Office Action Summary

10/687,811

DETAILED ACTION

Fig. 2

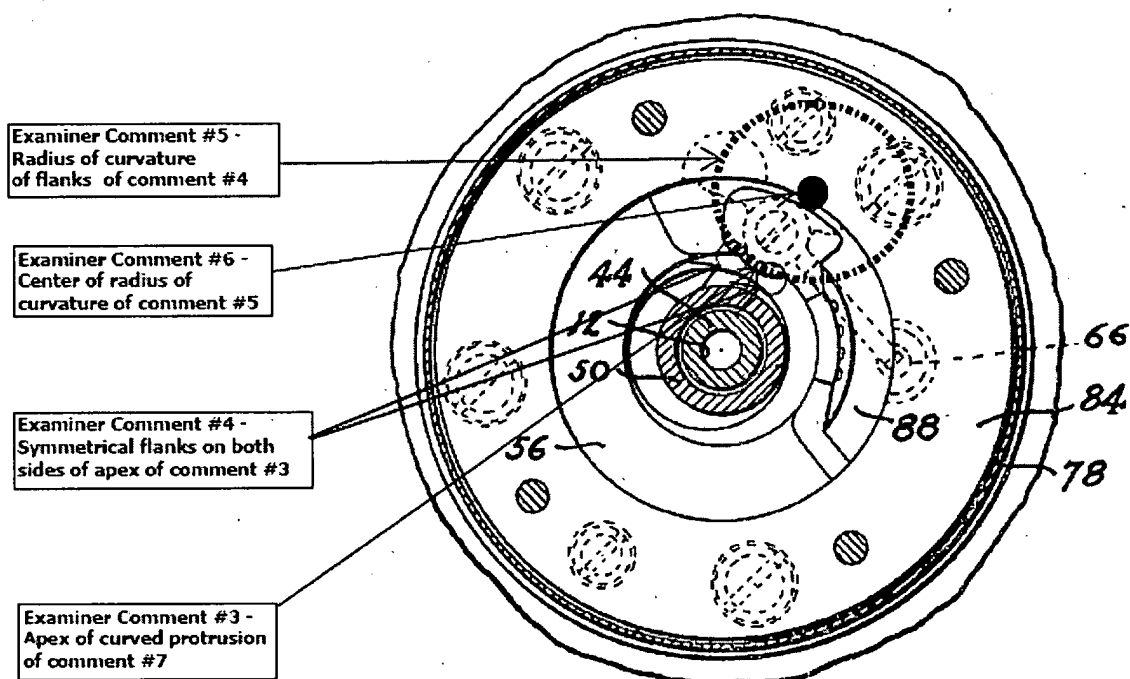
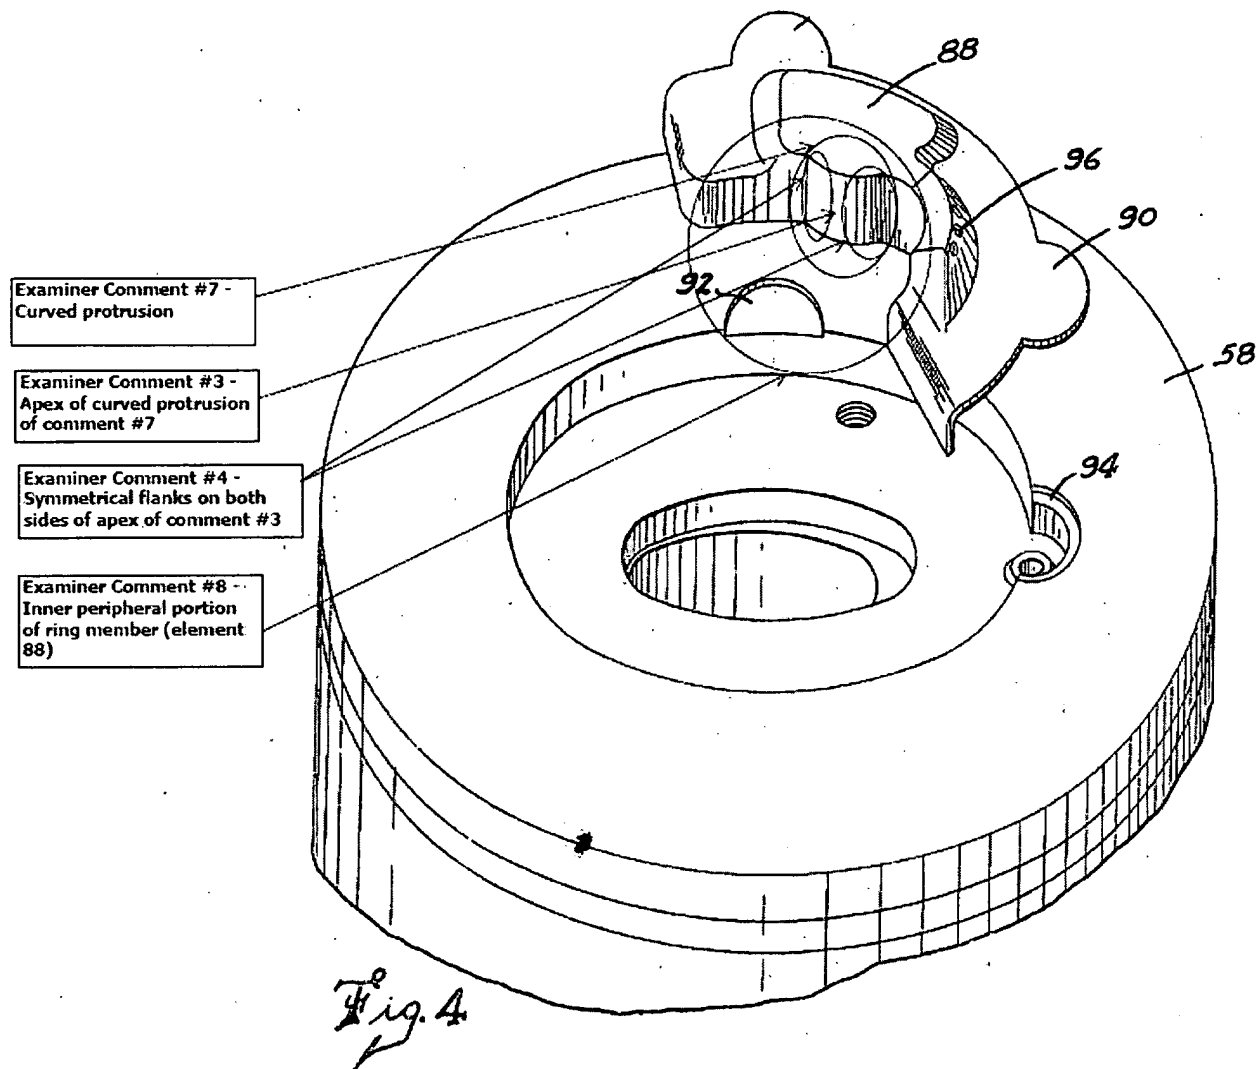
6. Claims 14-17, 19-20, 22-24, 26-27, and 29 rejected under 35 U.S.C. 103(a) as being unpatentable over Park JP - 2001248555, reference numbers herein taken from the US patent Park US 6,422,833, in view of Tarlton US 2,141,053. Park teaches all the limitations as discussed but fails to teach the following limitations for a compressor that are taught by Tarlton: (claim 14) a curved protrusion (fig. 4 – examiner comment 7) having an apex (fig. 2 and 4 – examiner comment 3) and flanks (fig. 2 and 4 – examiner comment 4) on opposite sides of said apex, with said flanks (fig. 2 and 4 – examiner comment 4) each have a radius of curvature (fig. 2 – examiner comment 5) such that a center (fig. 2 – examiner comment 6) of the radius of curvature is positioned outside of said cup-shaped stopper 74; (claims 15 and 22)

further in figures 2 and 4, Tarleton teaches flanks that are generally symmetrical relative to one another about an apex (fig. 2 and 4 – examiner comment 3); (claims 16, 19, 23, 26) a cup-shaped stopper 74 comprises a ring member 88, and said curved protrusion (fig. 2 and 4 – examiner comment 7) is formed by deforming an outer peripheral portion (fig. 4 – examiner comment 8) of said ring member 88 such that a resulting deformation of an inner peripheral portion of said ring member corresponds to said curved protrusion (fig. 2 and 4 – examiner comment 7); (claims 17, 20, 24, 27, 29) and figure 4 teaches a curved protrusion (fig. 2 and 4 – examiner comment 3) that extends along an axial direction of said cup-shaped stopper 74. It would have been obvious to one of ordinary skill in the art to modify a stopper to have an apex and flanks extending along an axial direction of a crankshaft in order to provide a shielding protrusion helps provide a quiet operation and reduction in wear to components (Tarlton – pg. 1 col. 1 ll. 41-48).

A copy of the figures with reference to Tarlton and the examiner's comments is provided on page following item 8 of this office action.

within said compressor chamber 60 in back and forth directions and a curved protrusion (fig. 4 – examiner comment 7) extends generally orthogonal to the back and forth directions. A combination of Park and Tarlton would teach the limitation of a curved protrusion extending in a direction orthogonal to a back and forth motion of a reciprocating piston. Suzuki teaches a protrusion 117 formed in a cup shaped stopper 16 receiving a crankshaft 7, extending in a direction orthogonal to a back and forth motion of a piston 12 in a hermetically sealed compressor 1 for the purposes of reducing the occurrence of a compressor body shaking against an inner wall of a compressor casing (Suzuki – col. 1 ll. 70- col. 2 ll. 2). It would have been obvious to one having ordinary skill in the art at the time the invention was made to provide a protrusion in a stopper for a compressor to reduce the occurrence of a compressor body striking against an inner wall of a casing of compressor in order to prevent damage to a compressor during normal operation (Suzuki – col. 1 ll. 70- col. 2 ll. 2).
